052-KY0-JC-KC1-TypeC
 052-KY0-JC-KC2-TypeC
 052-KY0-JC(EJ)-DG1-TypeC

052-M210S-RXCC-12B-PTC

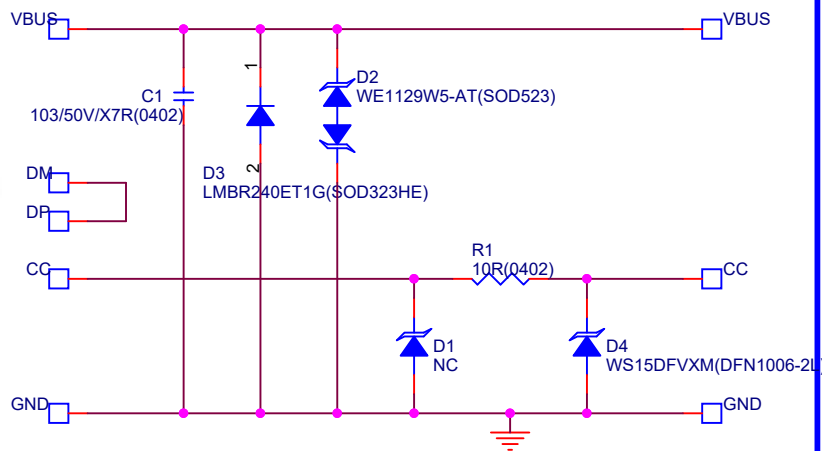
- 2026.03.19 : Added D4 and D5
- 2026.03.25 : Changed D5 to bidirection TVS, 15V, R23 is 0
- 2026.03.31 : Added C2 and D6
- 2026.04.13 : Changed D2 TVS
